MC68341

UPDATE TO MC68341 Integrated Processor User's Manual and Addendum

November 3, 1995

Figure 1. Retry Sequence

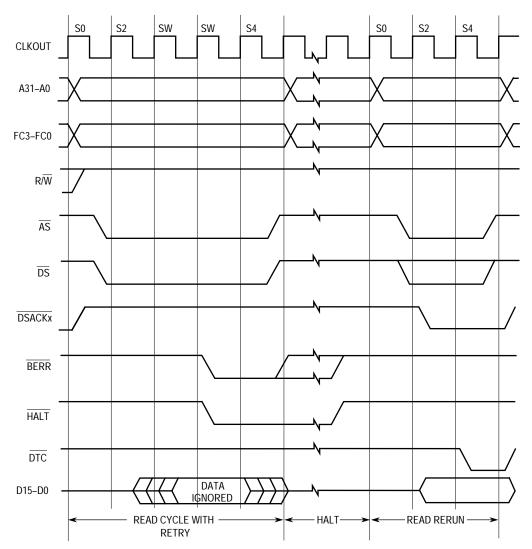
1. Negation of HALT and BERR for Retry Sequence and Late Retry Sequence.

Figure 3-25 and Figure 3-26 on pages 3-46 and 3-47 respectively, should show BERR and HALT being negated one-half clock cycle earlier. The corrected drawings are shown in Figure 1 and Figure 2 of this document.
